***Interactive comment on “Tracing groundwater salinization processes in coastal aquifers: a hydrogeochemical and isotopic approach in Na-Cl brackish waters of north-western Sardinia, Italy” by G. Mongelli et al.***

**G. Mongelli et al.**

Fig. 1. This is the corrected version of the original Figure 6

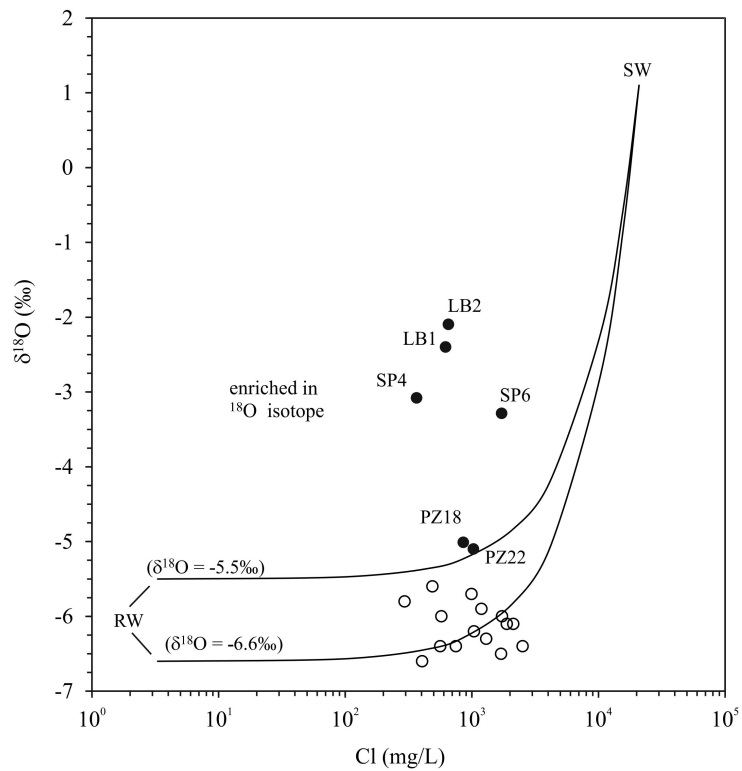
As suggested by the Referee #1 we have calculated the correct sea water-rain water mixing line based on oxygen-18 and chloride. We are going to correct Figure N-1 (corresponding to our Figure 6) and to change accordingly the related comment in the revised version of the manuscript. The mixing line supports the assumption that chloride and oxygen-18 in water may derive by mixing of rain water and sea water. Further, in the sulfate vs chloride Figure N-2 (corresponding to our Figure 4) the reviewer observes that only few sulfate values match the model of sulfate coming from mixing of

**Fig. 2.** This is the new version of the Figure N-5

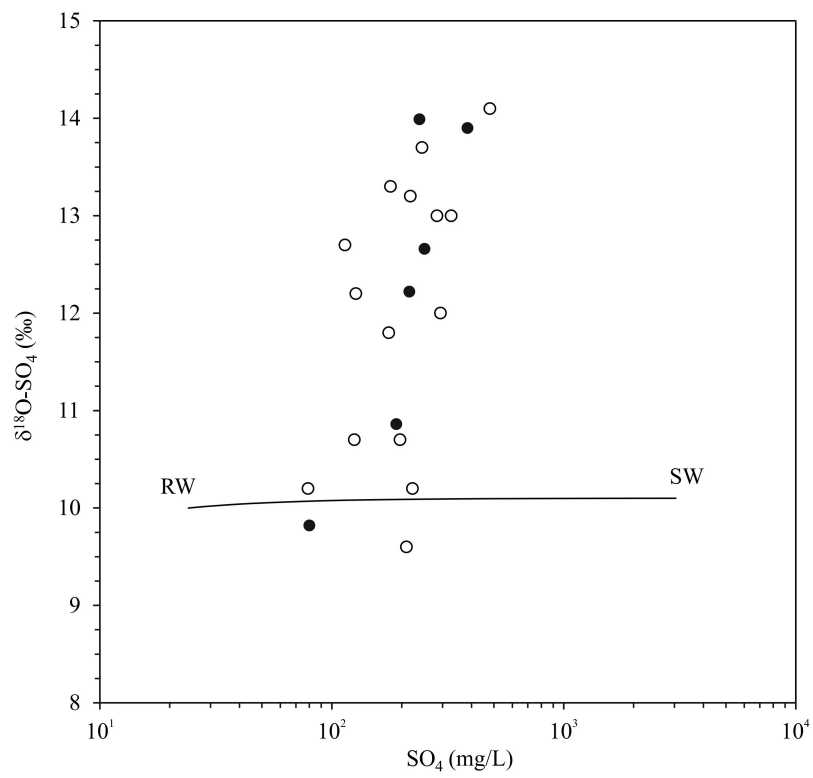
rain water and sea water. A similar result is obtained working with sulfur-34 isotopes in sulfate in water versus sulfate concentration (Figure N-3, corresponding to our Figure 9) and the reviewer suggests that “The deviation from the mixing model could be explained by exchange with or addition of SO<sub>4</sub> from gypsum in the subsurface, since the values for solids reported in the table are around 15 ‰. However, binary diagrams showing  $\delta^{34}\text{S}$  vs  $\delta^{18}\text{O}$  in dissolved sulfate (Figure 8) and  $\delta^{34}\text{S}$  vs SO<sub>4</sub> (Figure 9) clearly support the idea that the sulfate derives from dissolving sulfate from various rock sources of different age. More in general, it is interesting to observe that, as a general rule, the Na-Cl brackish waters from Nurra have contrasting features concerning both the elemental and the isotopic composition. Overall we strongly believe that the conclusions are sounded since: -the geology and the lithological features of the study area (see Figures 1 and 2), -the chemical composition of the investigated samples (see Figure 3, SO<sub>4</sub> vs Cl), -the lack of any correlation between distance from coastline and chlorine contents (see Figure 7), -the dual-isotope approach based on  $\delta^{34}\text{S}$  and  $\delta^{18}\text{O}$  in dissolved sulfate (see Figures 8 and 9), -the presence of halite in the gypsum levels all points toward water-rock interaction as the principal responsible for the Nurra Na-Cl brackish water composition. As concerns oxygen-18 isotopes in dissolved sulfate versus sulfate concentration along with mixing line between rain water and sea water (Figure 5), we agree with the reviewer: sulfate in water is trying to equilibrate its 18O isotopes with that in water, and this reaction would result in the  $\delta^{18}\text{O}$ -SO<sub>4</sub> values becoming more positive until equilibrium is attained. The evaluation of groundwater residence times in the Nurra area is an interesting task and will be the subject of a future research. In summary, we are going to revise the manuscript as follows: 1. correct Figure 6; 2. deleted the sentences (page 7, lines 2-9) and add, as shown by the reviewer, the new sentence on the interpretation for the source of chloride, where some but not all of the data fit the calculated mixing lines between sea water and rain water; 3. show that although both mixing (between seawater and rain water) and rock-water interaction appear to be taking place for sulfate, the data reported allow us to confirm that rock-water interaction is more likely; 4. add the new

Figure N-5 (oxygen-18 isotopes in dissolved sulfate versus sulfate concentration) in the text with comment; 5. modify accordingly the conclusions.
